# Technical Bulletin

Bulletin Ref: 11\_0005  
Date: 28th November 2011

## EXP-W10 Wired Expander

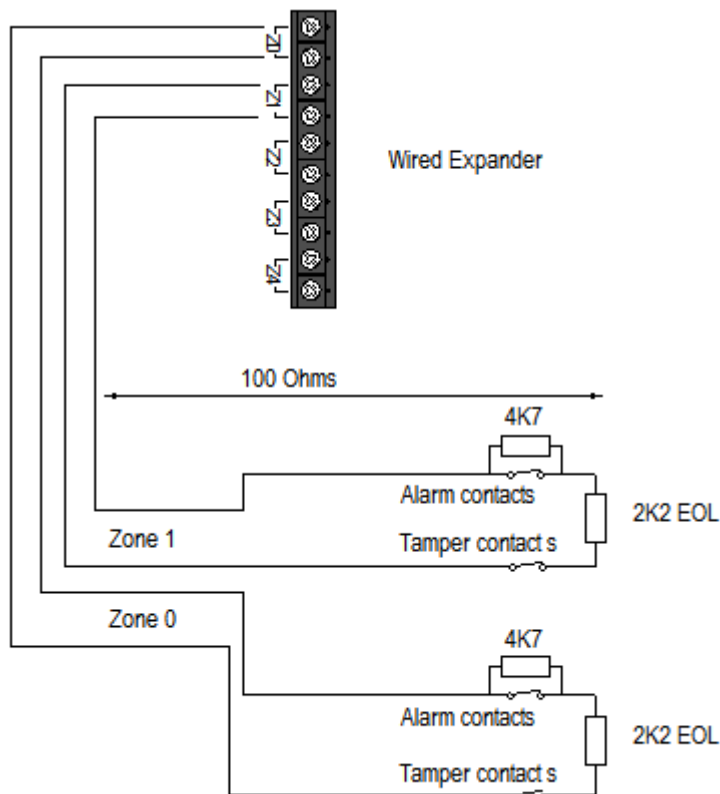
This bulletin applies to the EXP-W10, and the Installation Guide part number 12019972. The installation guide shows the FSL zone wiring as using three terminals for every two zones. This is incorrect. Each zone has its own dedicated pair or terminals. The diagram below shows the correct wiring:

Please note that the Installation Guides for the i-onEX range of control units show the correct wiring method for EXP-W10.
